**Central Sewershed Package 7 - UIW
Solicitation Number: CO-00322
Job No.: 18-4536**

**ADDENDUM 2
February 28, 2020**

SHEET **C-09**
 14 OF 52

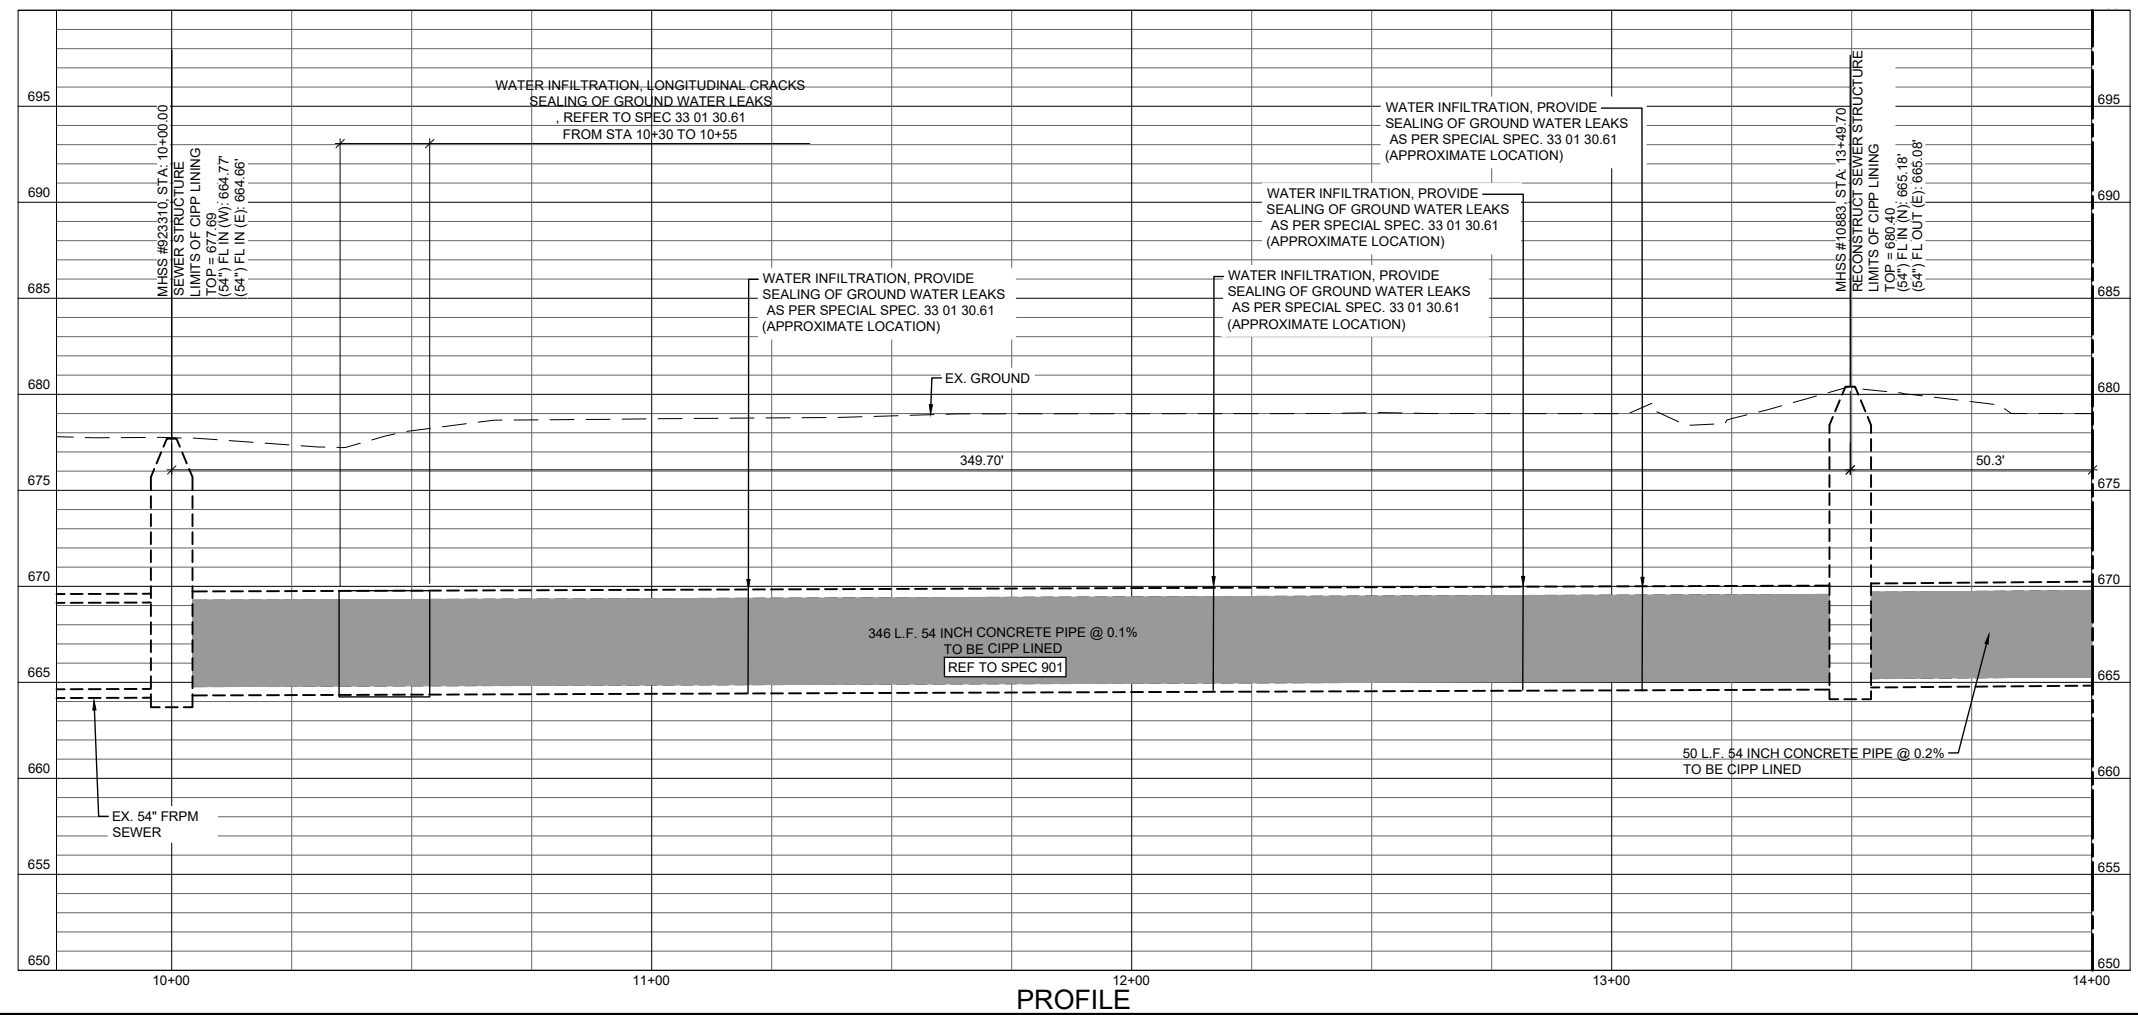
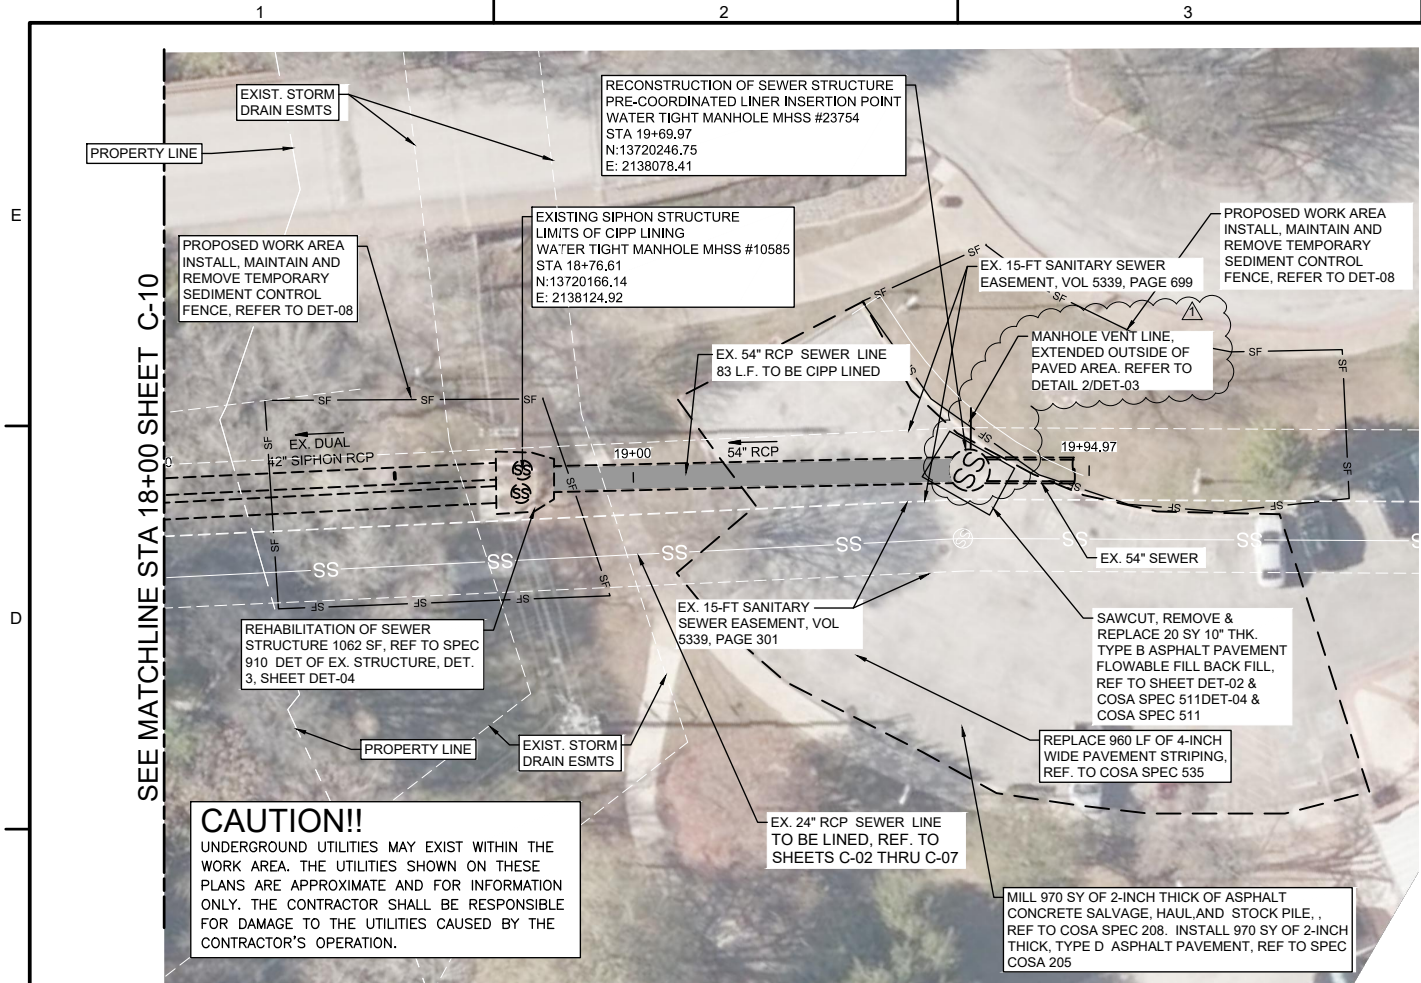
- 5. Question: Special Provisions to the Technical Specifications section 855.4.3 references constructing manhole vents as part of the manhole reconstruction where vents are called out on the plans, and there is a detail provided for performing this work on drawing DET-03 (sheet 30), but none of the manholes shown to be reconstructed appear to call for a vent to be constructed. Please clarify if any manholes will require a vent to be constructed, and if so, which ones.**

1. Plan Sheet C-09 (Central Sewershed UIW, 54-inch sewer plan and profile Sta 10+00 to 14+00)- Replace sheets dated 1/28/2020 with attached sheet dated 2/28/2020.
2. Plan Sheet C-11 (Central Sewershed UIW, 54-inch Sewer plan and profile Sta 18+00 to end)- Replace sheet dated 1/28/2020 with attached sheet dated 2/28/2020.

Response: Manholes 10833 (Sheet C-09) and 23754 (Sheet C-11) require vents. See attached revised sheets for vent locations.
